BRIDGE REPLACEMENT-CCS
BRF-093-1(030)--38-09

INDEX OF SHEETS	
No.	DESCRIPTION
A Sheets	Title Sheets
A.1	Title Sheet
A.2	Location Map Sheet
A.3 - 10	Concept
A.11	Questions
B Sheets	Typical Cross Sections and Details
* B.1	Typical Cross Sections and Details
D Sheets	Mainline Plan and Profile Sheets
* D.1	Plan & Profile Legend & Symbol Information Sheet
* D.2	IA 93
G Sheets	Survey Sheets
G.1 - 3	Reference Ties and Bench Marks
G.4	Horizontal Control Tab. & Super for all Alignments
J Sheets	Traffic Control and Staging Sheets
J.1 - 2	Traffic Control Plan
U Sheets	500 Series, Mod.Stds. and Detail Sheets
* U.1	500 Series, Modified Standards and Detail Sheets
V Sheets	Bridge and Culvert Situation Plans
* V.1	Bridge and Culvert Situation Plans
W Sheets	Mainline Cross Sections
* W.1	Cross Section Legend
* W.2 - 5	Mainline Cross Sections
* Color Plan Sheets

Project Concept Statement; (Final, D0)

Questions

MODIFIED STANDARD ROAD PLAN	REVISION	
	4	MODIFIED
BR-211		
SHEET 1 of 1		
MODIFICATIONS: Extended Curb to the End of Non Reinforced Section		
APPROVED BY DESIGN METHODS ENGINEER		
BRIDGE APPROACH (ABUTTING PCC OR COMPOSITE PAVEMENT)

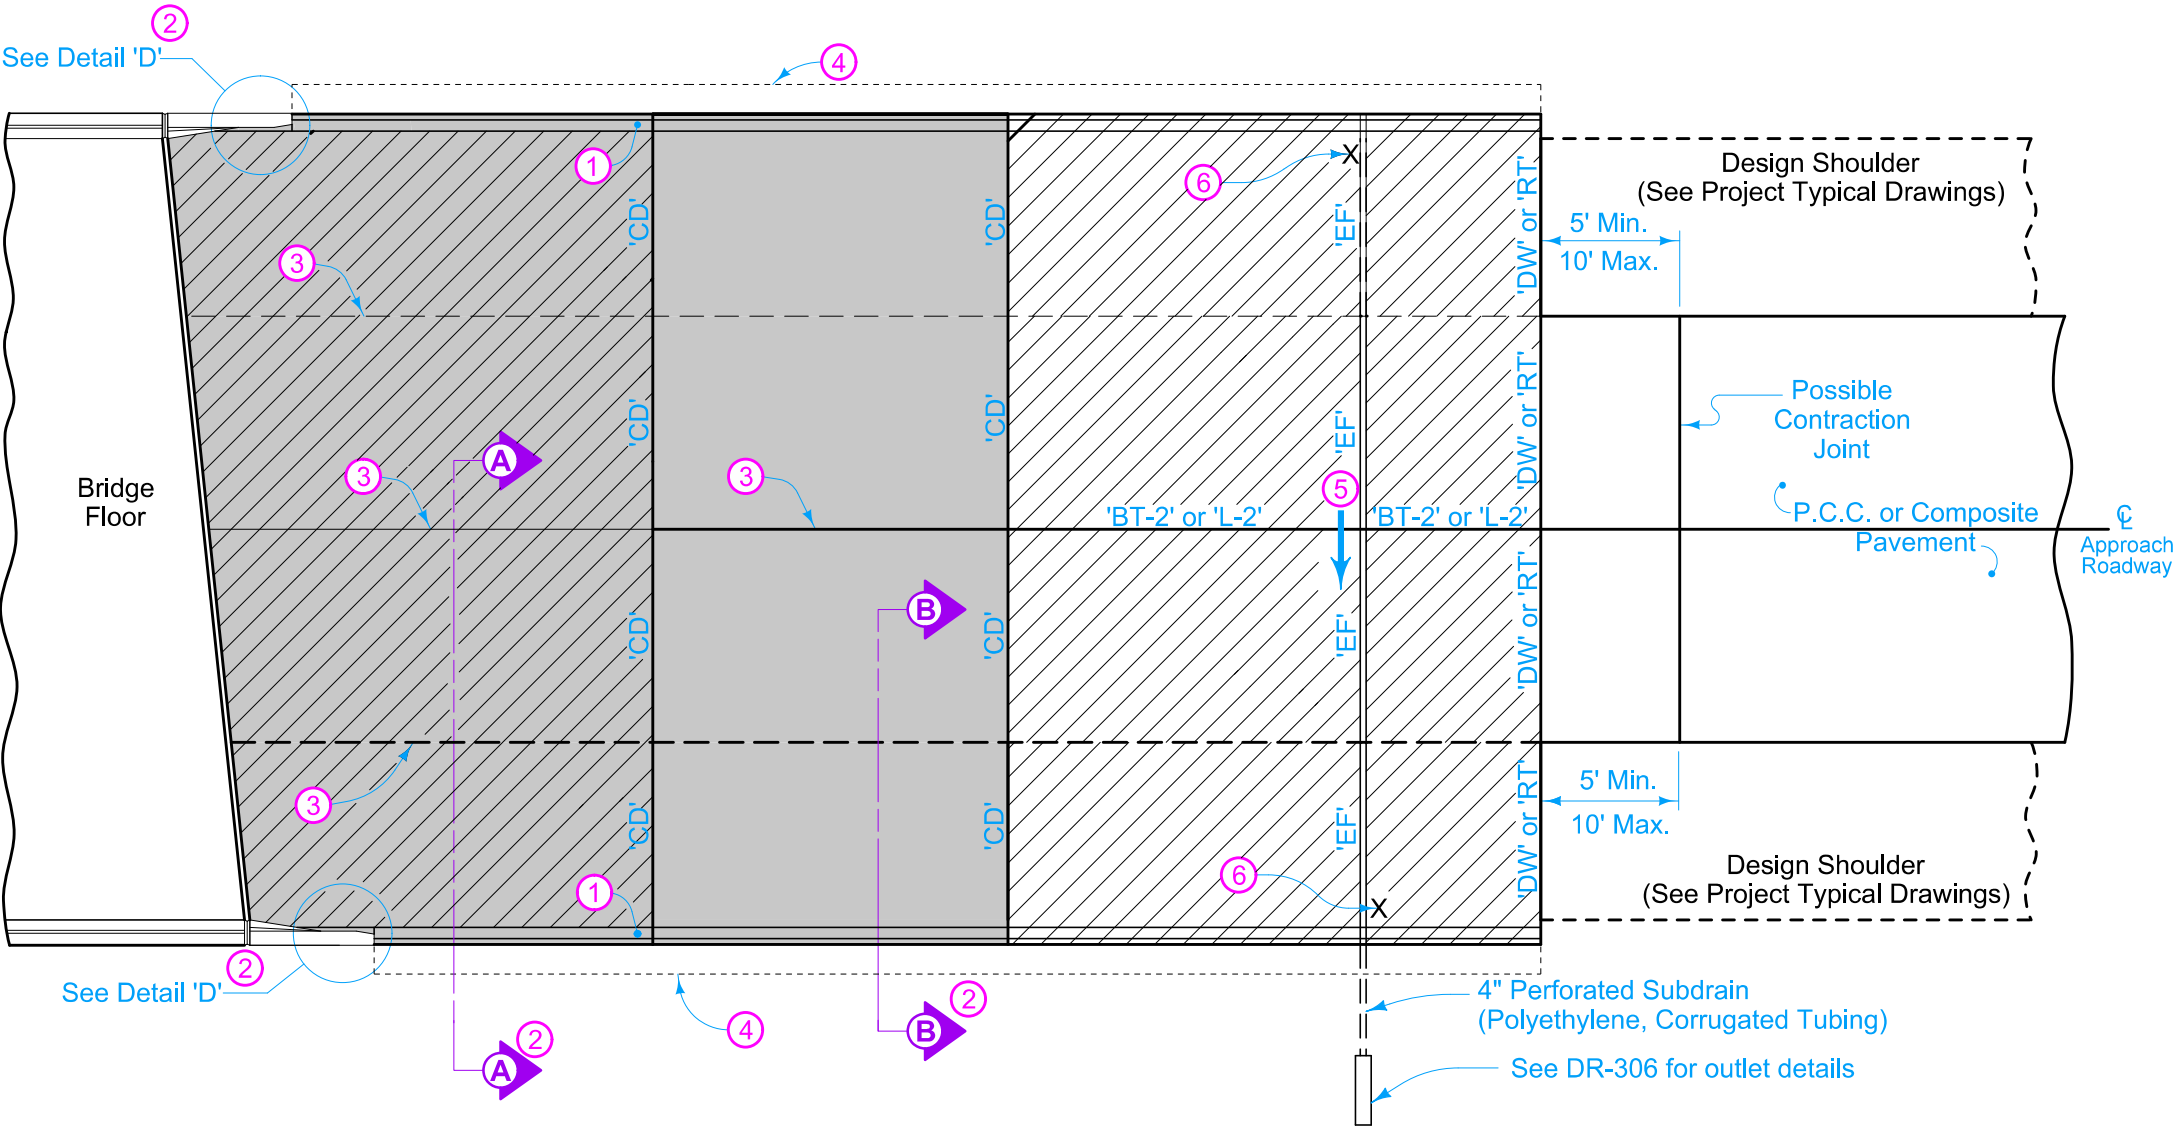
2. Currently the bridge approaches are designed using BR-211. The bridge on this project is a Slab Bridge, should we use BR-205 instead?

Move forward with BR-211. Final bridge designer may choose to switch approach type.
